Service Letter No. 136A

September 2, 1952

TO: Owners of PA-20 and PA-22 Airplanes with serial numbers 20-1 through 20-923 and 22-1 through 22-775

SUBJECT: Chafing of Fuel Line and Fuel Valve Operation

VIEW OF LEFT SIDE FROM INSIDE CABIN

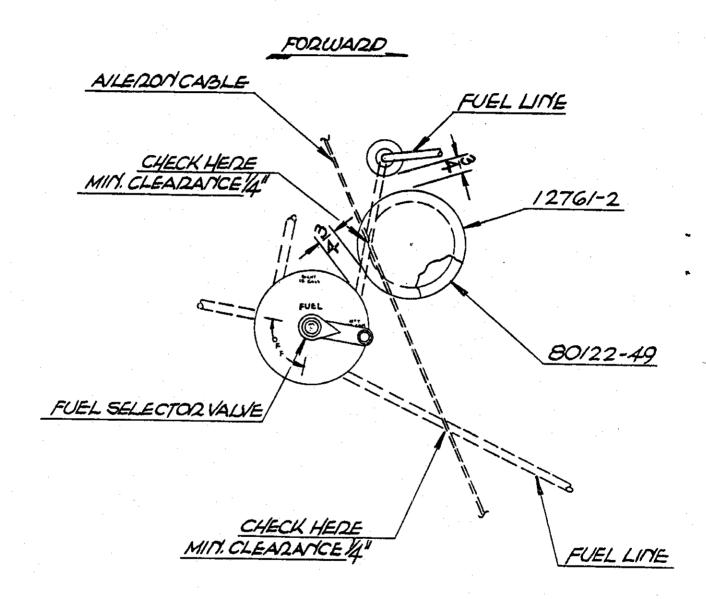
To accomplish this, dope the pyralin grommet, 80122-49, to the fabric inside the cabin as shown in the sketch. Cut away the fabric enclosed within the grommet.

Inspect the fuel lines for evidence of chafing by the aileron control cable. Check the clearance between the fuel lines and the cable. If 1/4" or more clearance exists no further action is required. If 1/4" minimum clearance has not been provided, form the fuel lines by hand to obtain this minimum clearance. Exercise care while forming to avoid crushing or kinking the fuel lines.

Upon completion, install the cover, 12761-02, as shown in the sketch.
